RE: Ciara at Anatolia (DD9693)

WALKSacramento has reviewed the major design review routing for Ciara at Anatolia (DD9693). The project proposes 4 floor plans and front- and side-yard typical landscaping plans for 139 single-family homes in the Anatolia IV subdivision.

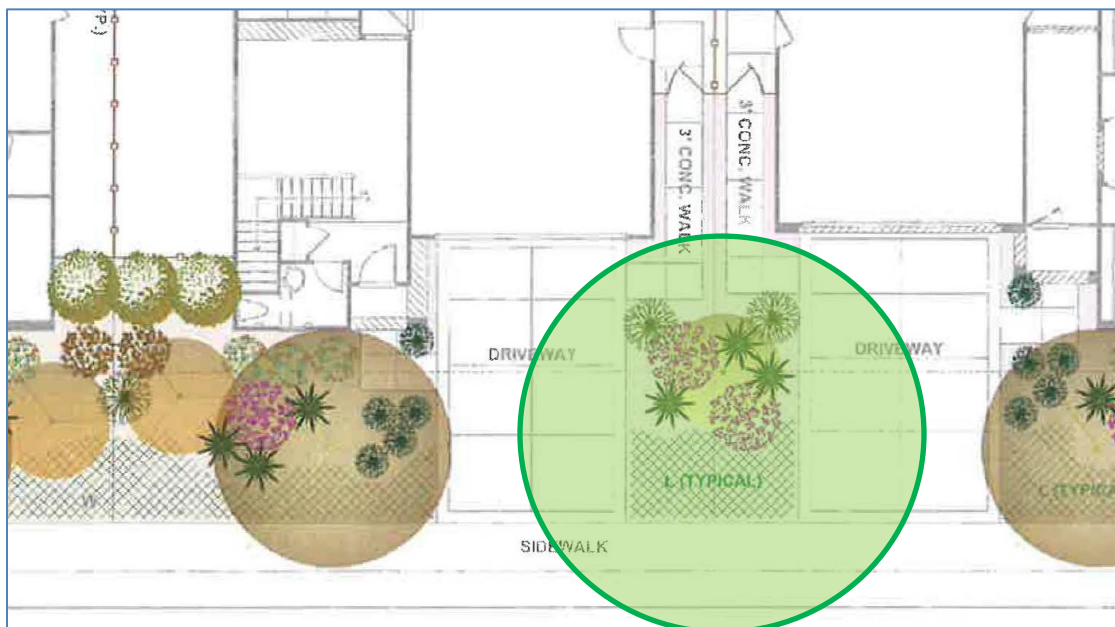
Conceptual Landscape Layout sheet LC-1.2 shows the typical corner lot landscape layout for the side yard. We believe there may be two situations – side yards with attached sidewalks and side yards with detached sidewalks - where there’s an opportunity to plant larger trees. The street shown in the diagram has attached sidewalks and while the fence is at the 12.5’ P.U.E. setback, the house is set even further back from the street. The green rectangle superimposed on the diagram below indicates the opportunity area for side yards along attached sidewalks.

WALKSacramento recommends adding larger trees to the Street Tree list and the typical landscape layouts so that pedestrian-friendly environments are more likely to be created within the Ciara neighborhood.
